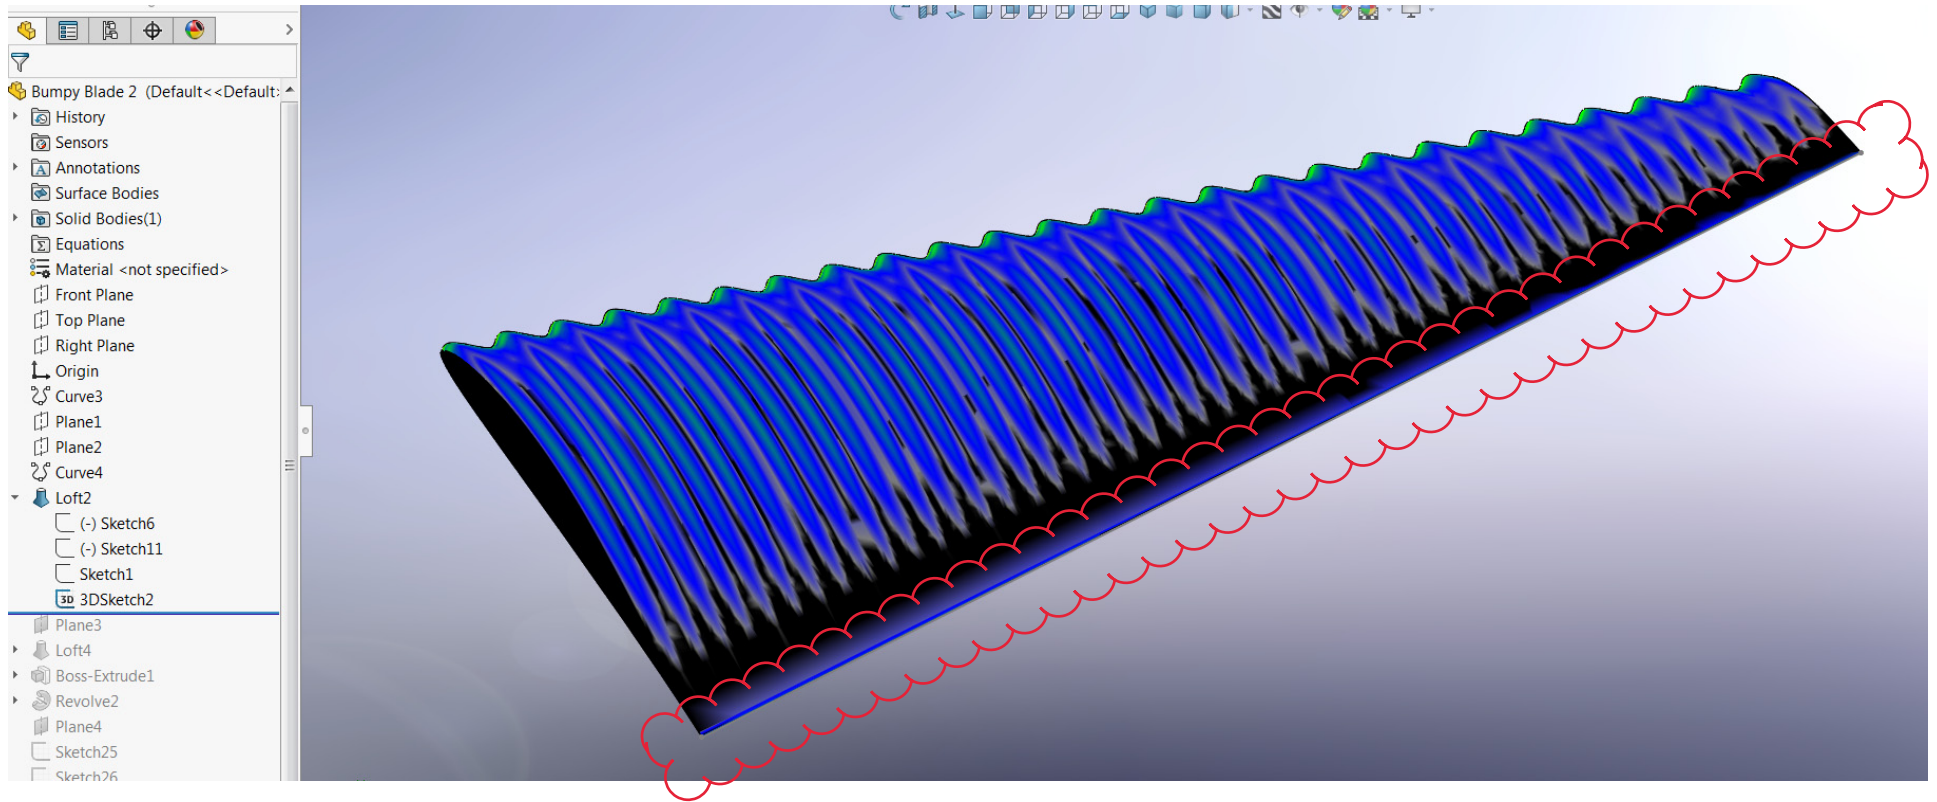
With Curvature Colors Displayed: Zoomed out looks okay but zoom in a bit since the back edge of the blade has some colors to it, let's check that out closer.

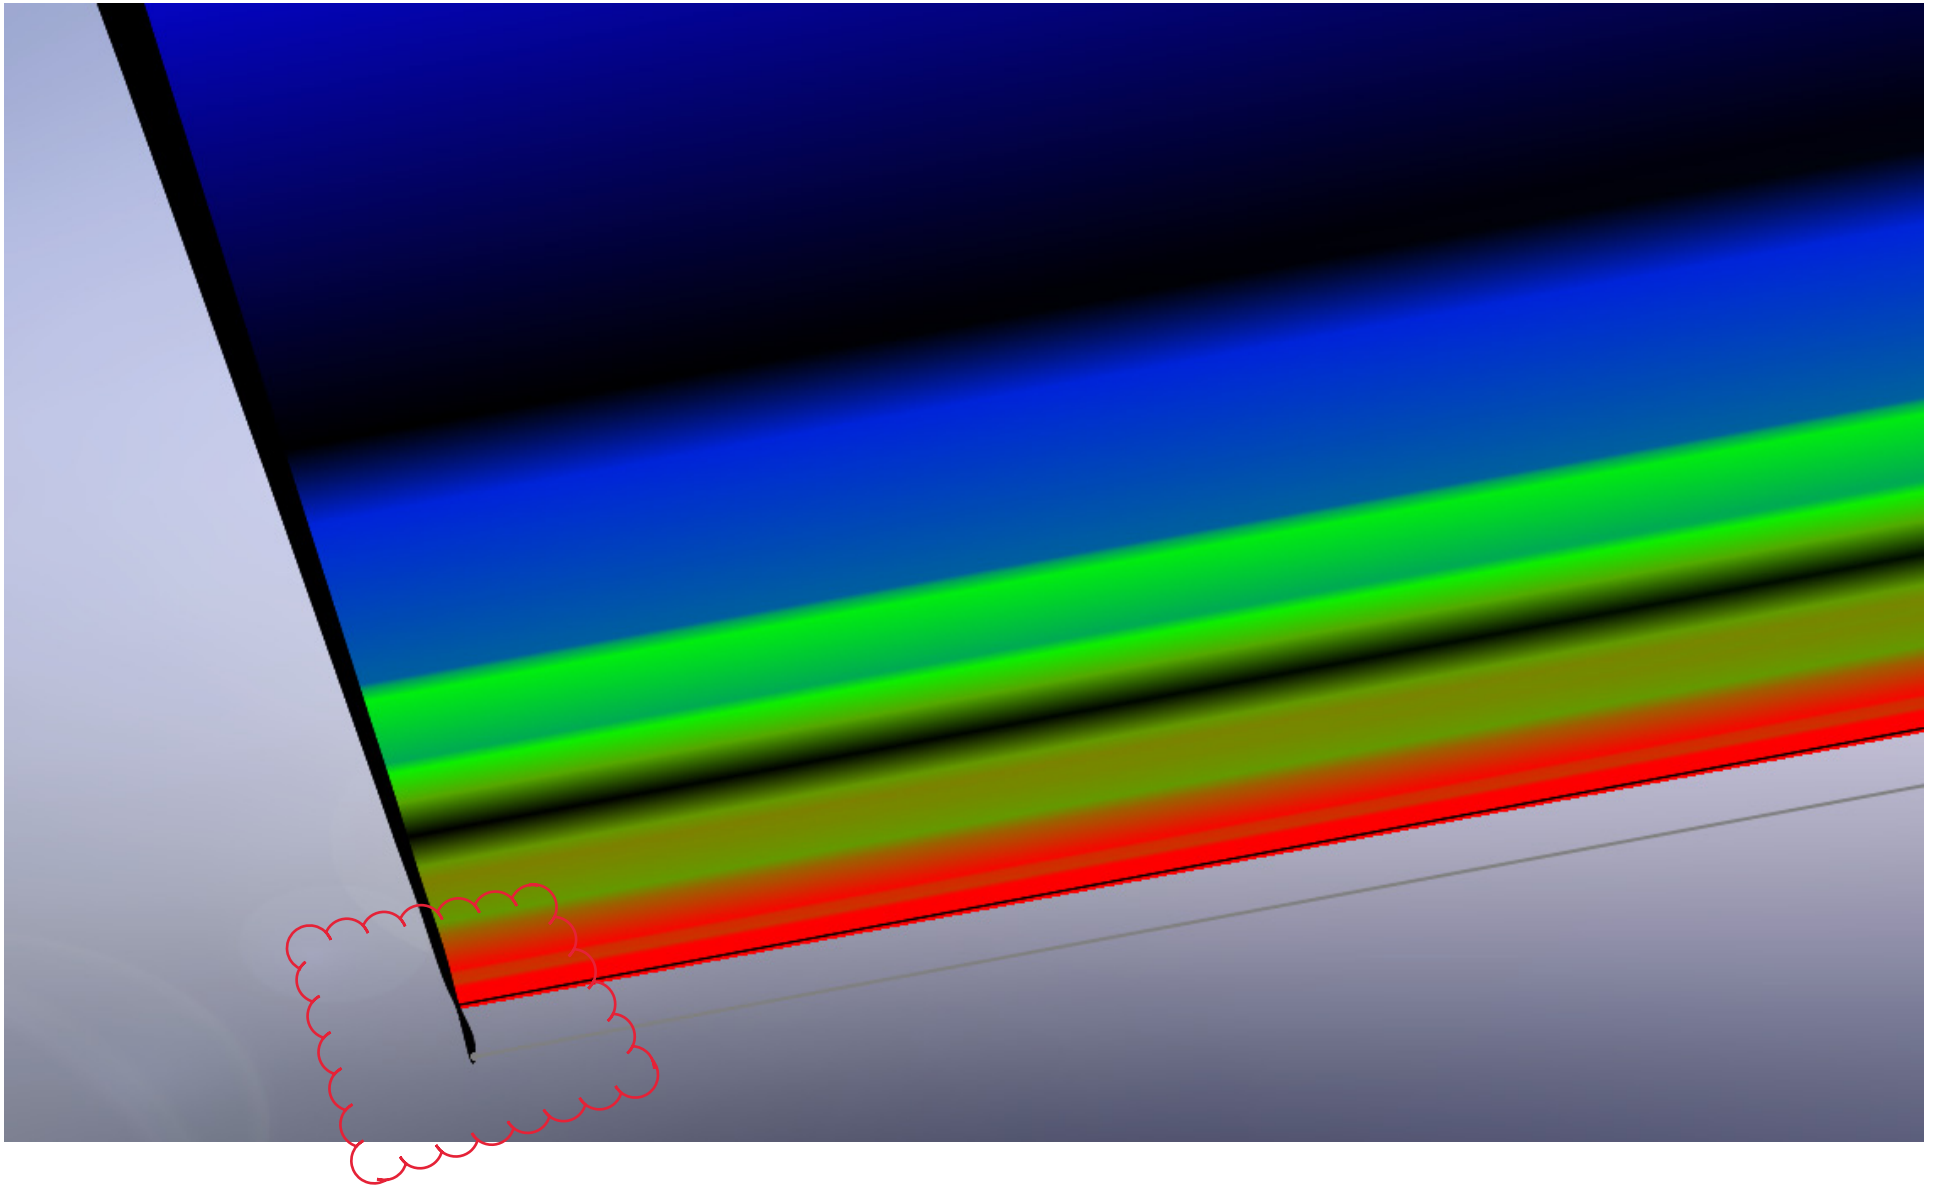
Hmm, strange colors. Not sure it should show interrupted colors since it is a continuous curve, or rather it should be. And what the Hell is that “dog tag” of a surface doing there???

Zoomed in to Clouded area: Sketch 6

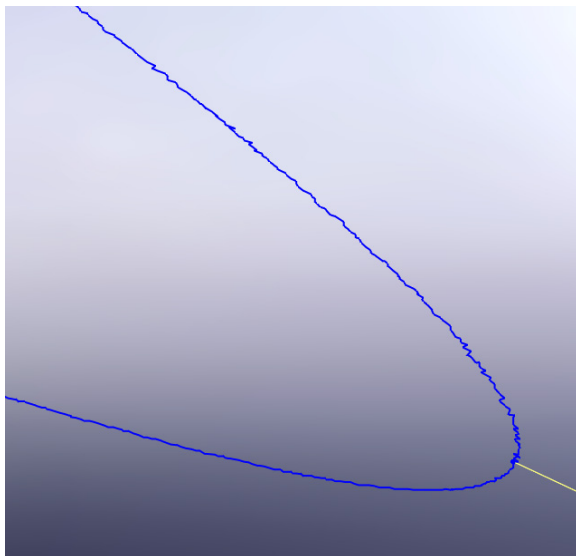
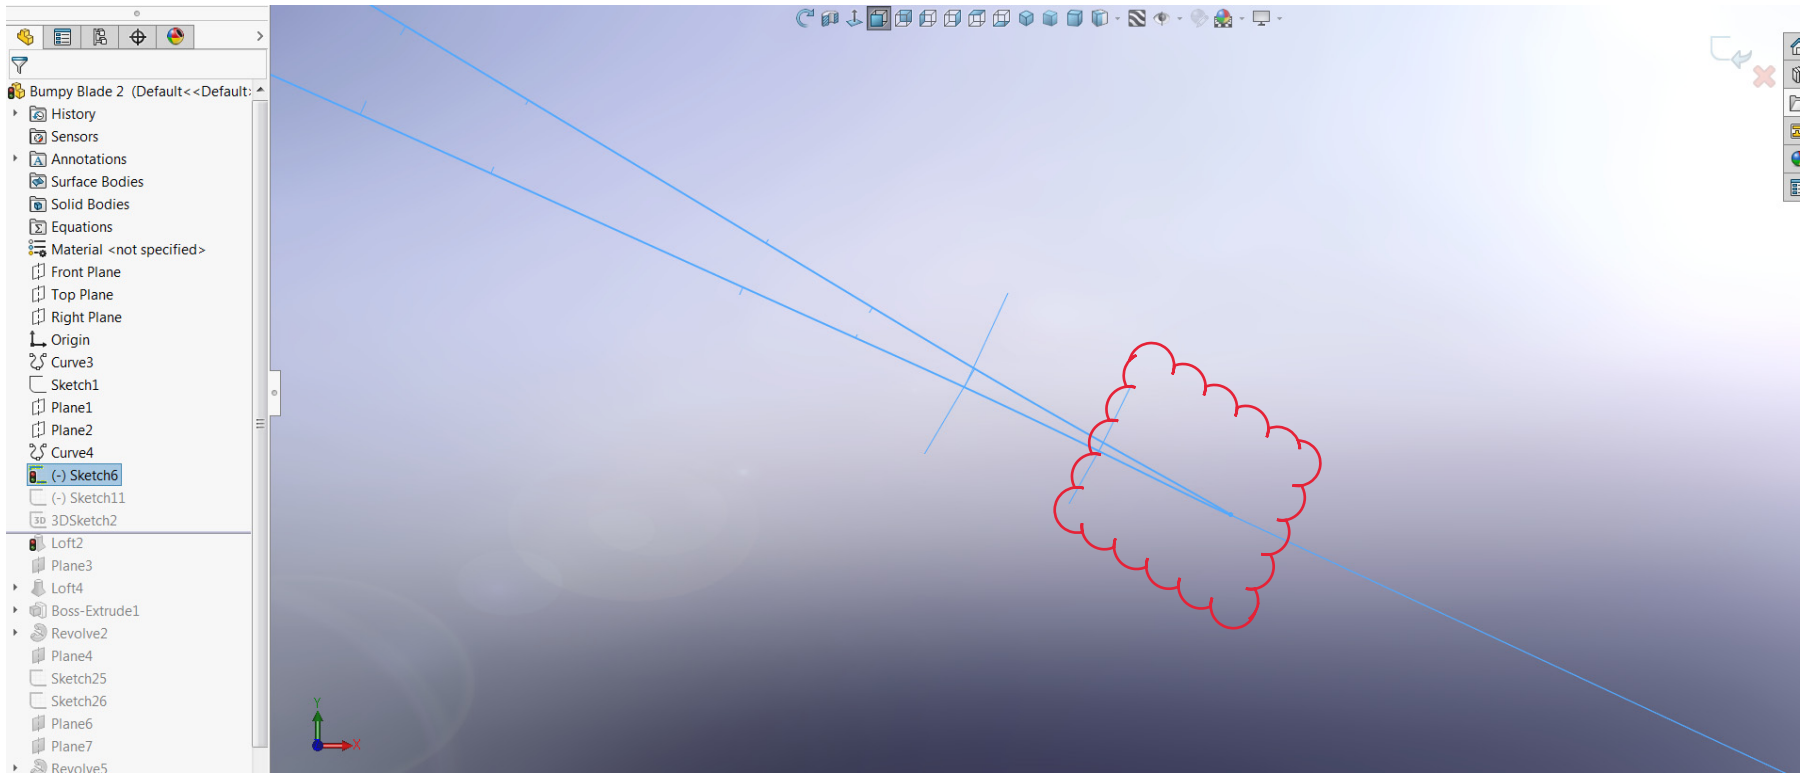
Sketch 6: Curvature combs on, looks suspicious to a trained eye.

I believe you need to draw the curve as a native Solidworks Curve as it is obviously not defined well. Try That.

When you zoom in to Lofted profile you see some bizarre surfaces have been generated. I believe this is causing you mesh problems. Check the other imported profile also.
